Port of Seattle (Jalyn Buckley)

Thank you for the opportunity to review the public comment draft Remedial Investigation (RI) report for the Glacier Northwest Site (Glacier NW Site). On behalf of the Port of Seattle, please find attached our comments and accompanying figures on the Glacier NW Site draft RI report.

Focus Area Conceptual Site Model

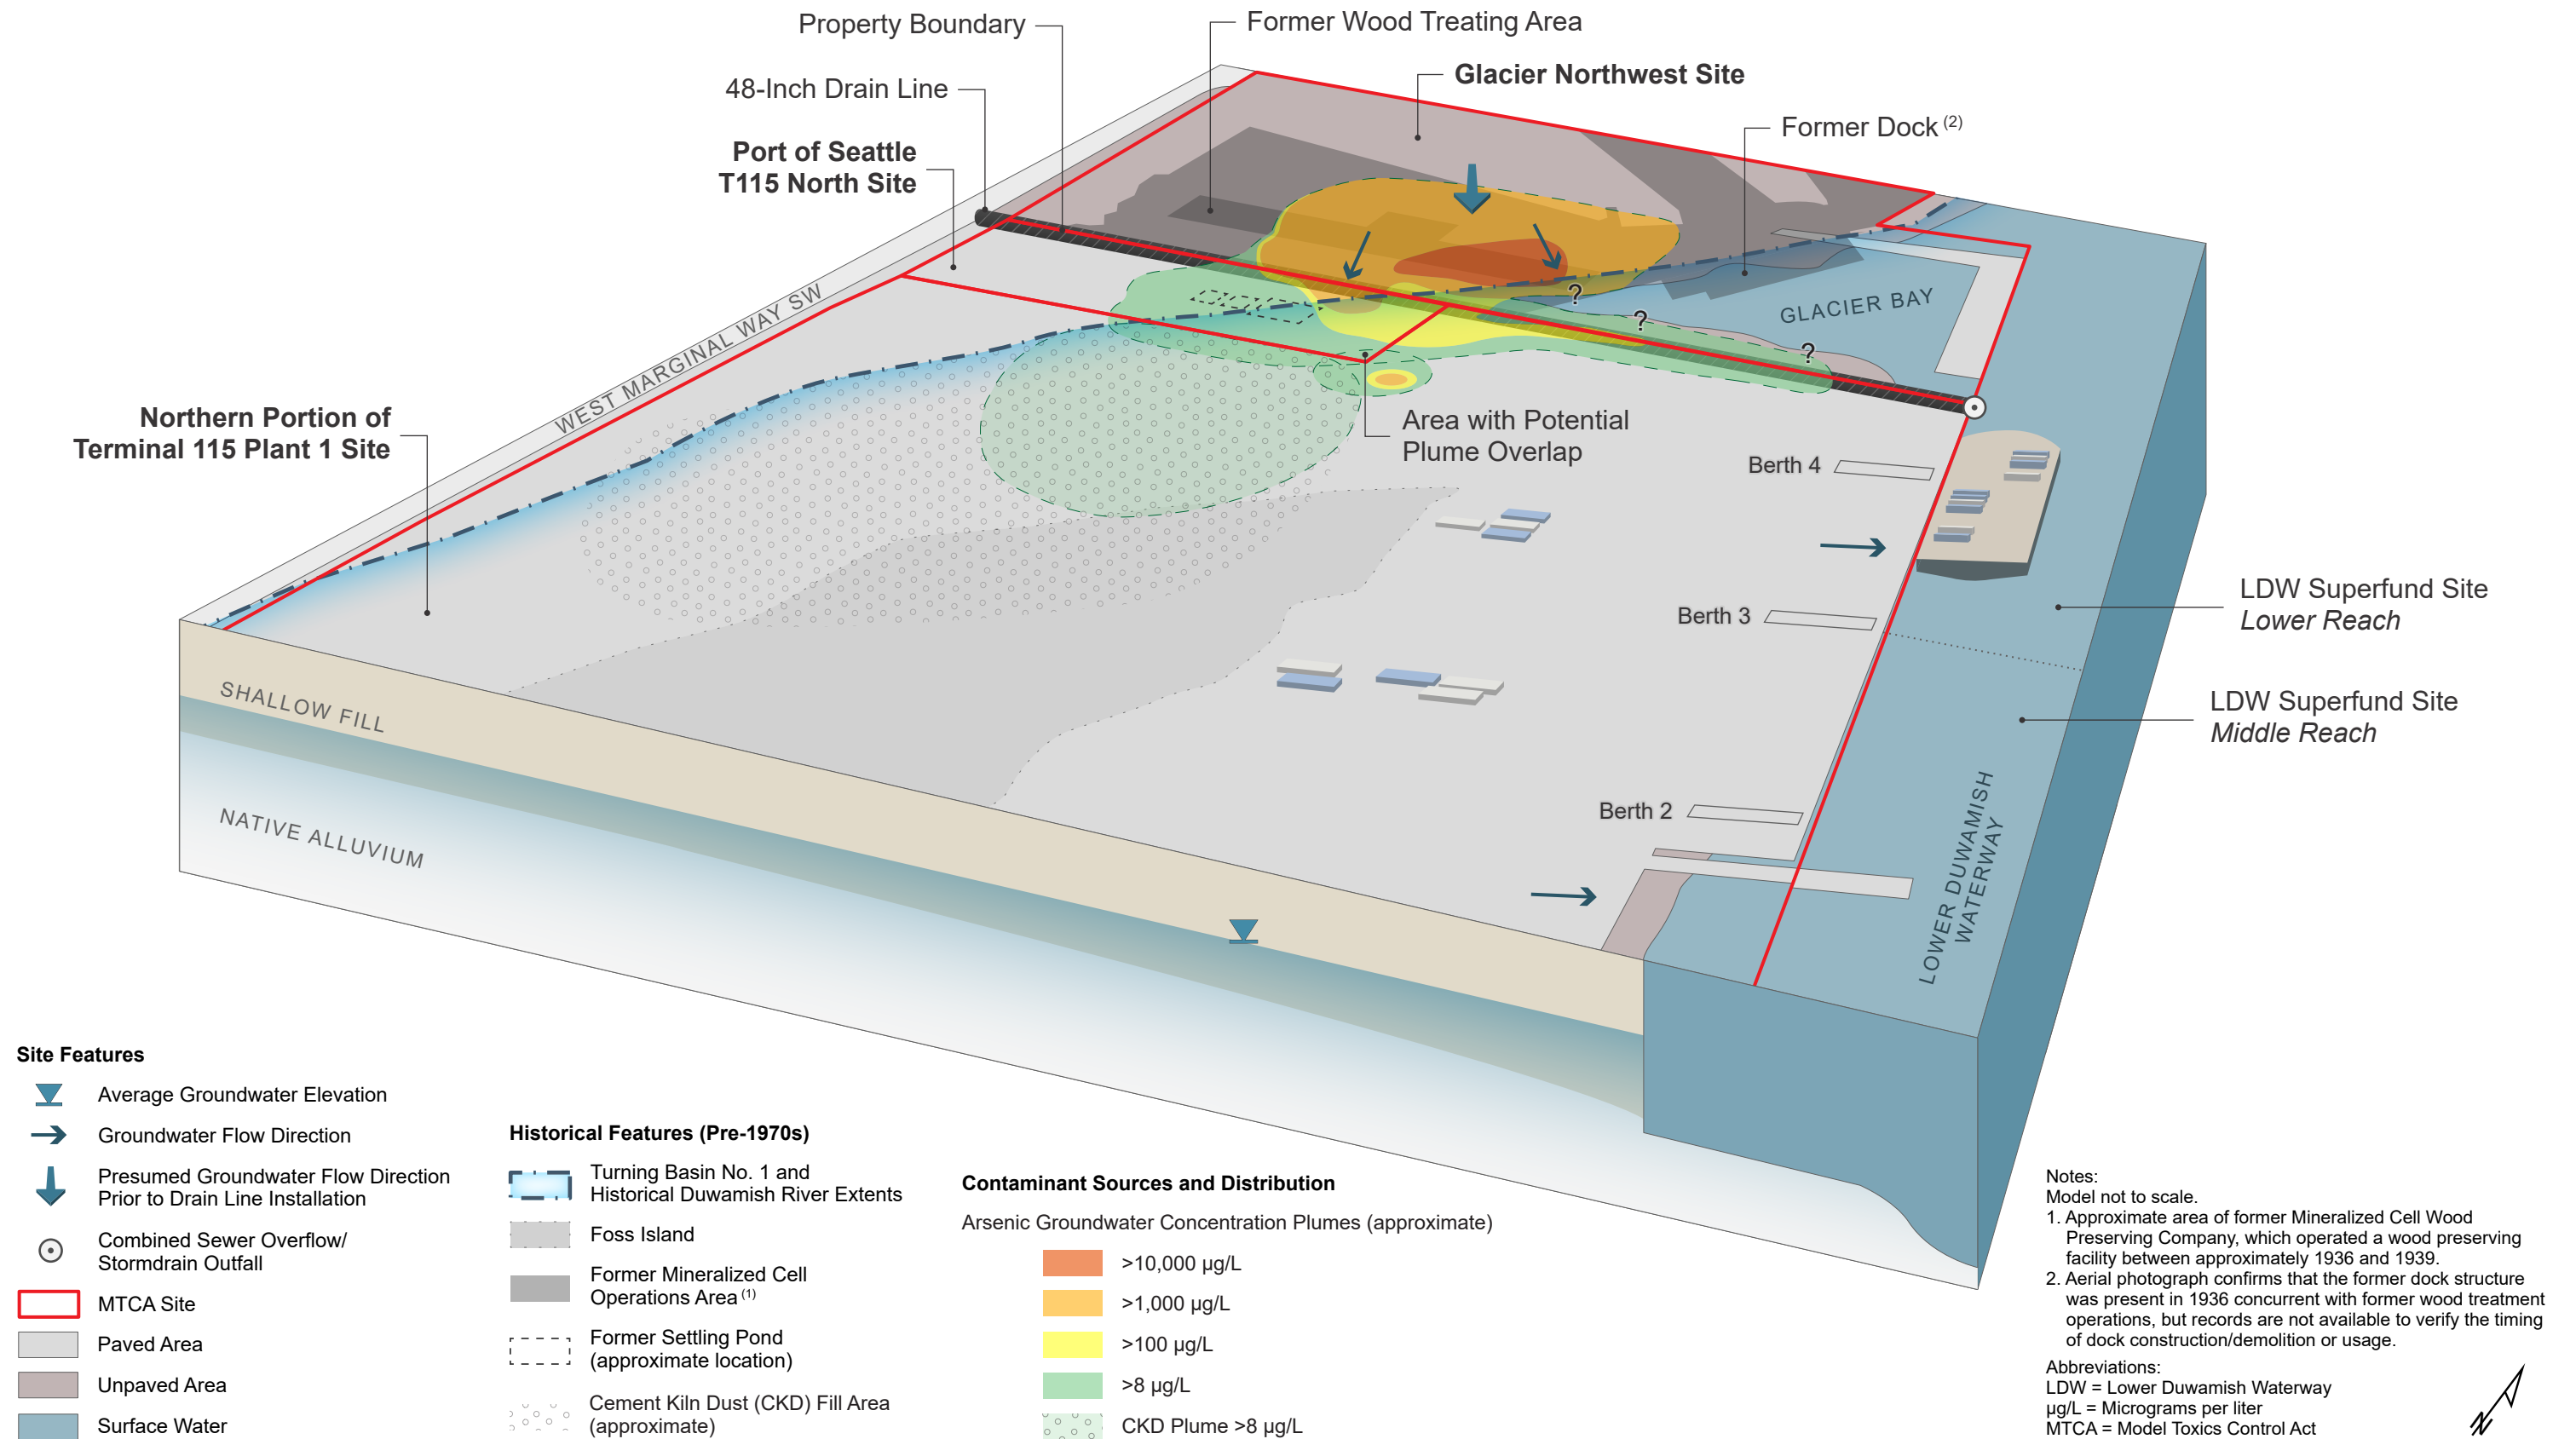
The Port is submitting the following comments on the Glacier NW Site draft RI report (draft RI). For Ecology’s reference, figures that present arsenic and pentachlorophenol (PCP) occurrences in shallow and deep groundwater near the Glacier NW and T-115 property line, a cross section and a focused conceptual site model (CSM) that span the property line are attached to accompany our comments.

8	2.10.2.1	<i>General: SPU 48-inch diameter drainage pipe</i> <i>Groundwater elevation data indicate the presence of a depression in the groundwater table in the southeastern portion of the Site, which is caused by the 48-inch-diameter SPU stormwater line that runs parallel to and south of the Site (Figure 2-22)</i> <i>Groundwater immediately surrounding the SPU stormwater line has not been sampled, but groundwater data from nearby shallow monitoring wells MW-3S, MW-26S, and MW-27S, located on the Property and MW-14, located on the Port of Seattle property are indicative of the quality of groundwater discharging to the bedding material of the SPU stormwater line."</i>	Given the relevance of the 48-inch SPU drainage pipe to the CSM (see Comment 11), it would be beneficial to include a stand-alone section in Section 2.5 of the draft RI about this pipe, including construction details. The pipe, which is located on both the Glacier NW and T-115 properties, is described in Section 2.10.2.1 as a preferential flow pathway for shallow groundwater that affects groundwater flow patterns at the Glacier NW, T-115 North and T-115 Plant 1 sites. Since the pipe installation in 1972, groundwater that was previously assumed to flow toward the historical LDW shoreline has been locally redirected toward the drainage pipe and a portion of the flow discharges to the pipe bedding as it traverses the property line.

Cmt No.	RI Section	Statement in Draft RI	Port Comment
			(3) T-115 Plant 1 areas east of T-115 North (not begun until 1969 or 1970).
11	7.5.2.2	<i>General: Preferential Migration Pathways</i> <i>As discussed in Section 2.10.2.1, groundwater in the southern portion of the Site and under the Port of Seattle property appears to be influenced by a preferential pathway along the 48-inch diameter SPU stormwater line located south of the Site.</i>	The focused CSM figure attached illustrates how the arsenic groundwater plume migrated from the Glacier NW property toward the historical shoreline and onto the T-115 property. After filling the eastern portion of T-115 North, plume migration continued into those areas. After installation of the SPU drainage pipe in 1972 (see Comment 9), localized groundwater flow shifted toward the pipe. Pipe bedding, which is at the same elevation as shallow groundwater, provides a preferential pathway for groundwater contaminants (i.e., arsenic) to be intercepted and flow towards the LDW, while the rest of the plume continues to migrate onto T-115 property. Elevated arsenic concentrations in shallow groundwater near the drainpipe confirm migration onto the T-115 property (refer to arsenic figures and cross section). The CSM in the draft RI should be updated to also include preferential migration of contaminated groundwater along the pipe bedding and onto T-115 property. Also, considering its immediate downgradient location from the former arsenic source area, include an analysis of the pipe’s effects on the arsenic groundwater migration as part of the CSM, including how the pipe bedding and tidal flushing along the pipe bedding affect arsenic plume migration. This information is important and will help inform the Glacier NW Site Feasibility Study and later design documents.
